**From:** "Donald E. Vanover" <DEVanover@erineng.com>  
**To:** <dxw@nrc.gov>, <rlp3@nrc.gov>  
**Date:** 7/16/03 11:43AM  
**Subject:** Draft Dresden SAMA RAI Responses

## **RAI 1**

**The SAMA analysis is based on the most recent version of the Dresden Nuclear Power Station (DNPS) Probabilistic Safety Assessment (PSA) for internal events, i.e., 2002 Update, which is a modification to the modified IPE submittal transmitted to the NRC in June 1996. Please provide the following information regarding this PSA model:**

**Figure 3-1  
Typical Dresden Level 2 Containment Event Tree**

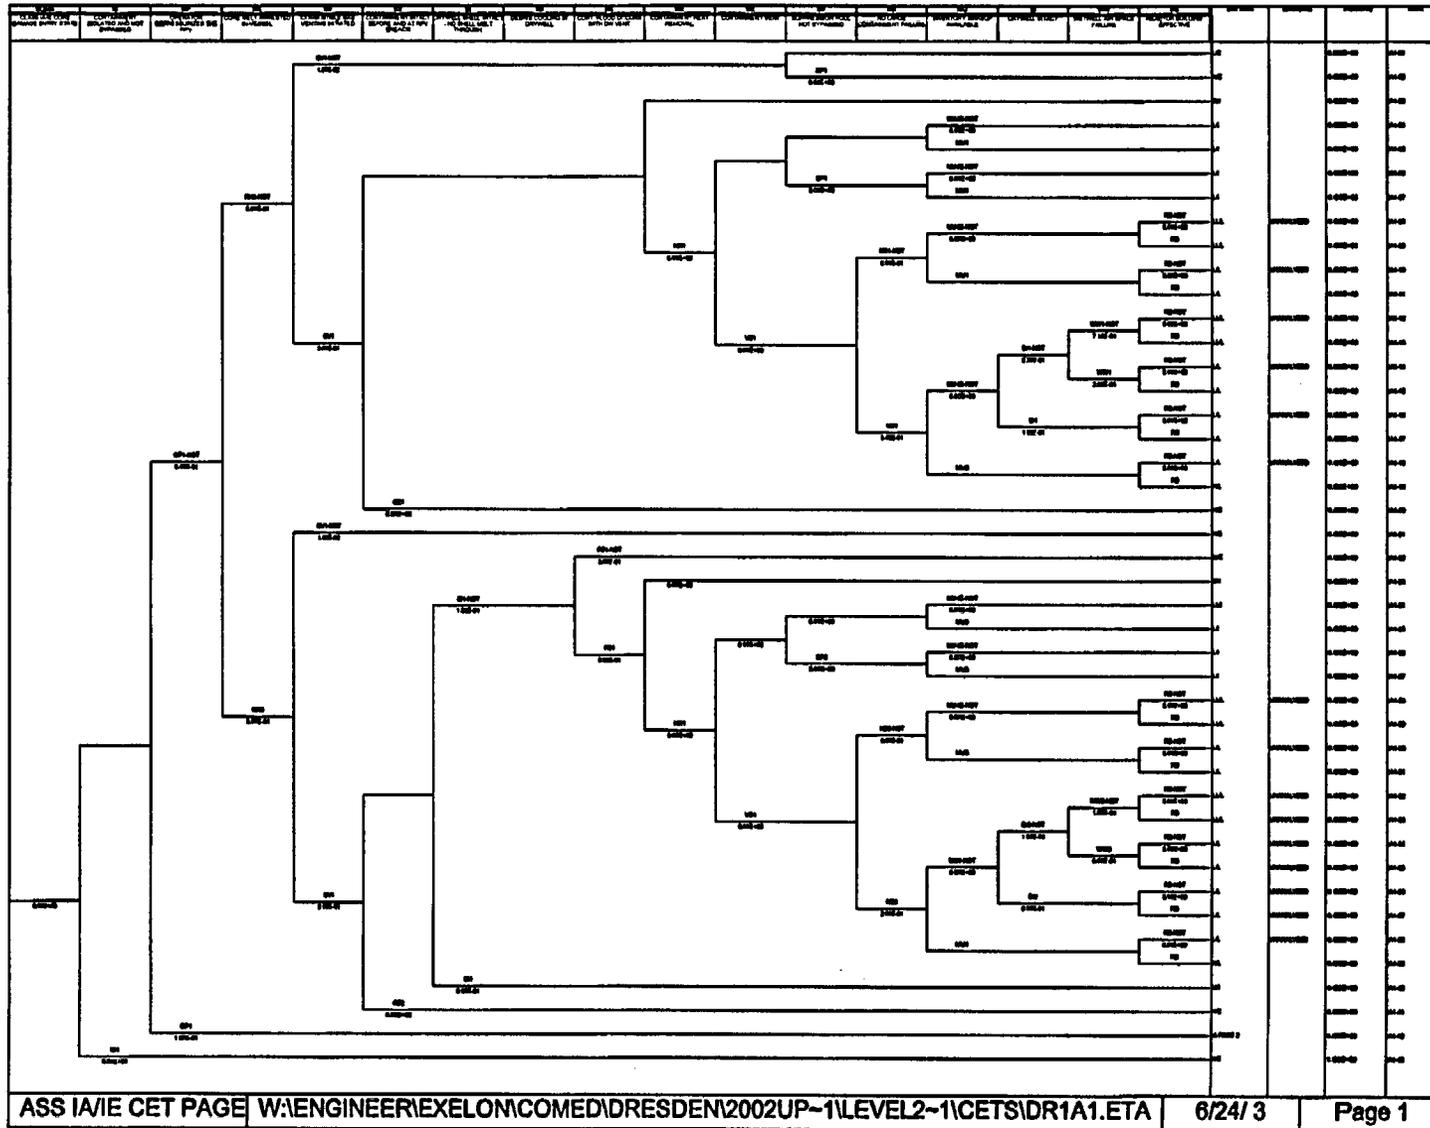
***"[Provide] each release (consequence) category used in the Level 3 analysis (as listed in Column 1 of Table 4-5), the specific source terms used to represent each release category, and a containment matrix describing the mapping of Level 1 results (plant damage state frequencies) into the various release categories."***

The CET calculation for each cutset uses Boolean logic and fault tree models to process the incoming Level 1 cutsets to ensure that the resulting Radionuclide release frequencies properly reflect the impact on release magnitude and timing of the containment and containment mitigation systems. A typical CET (for Accident Class 1A) is provided in Figure 3-1.
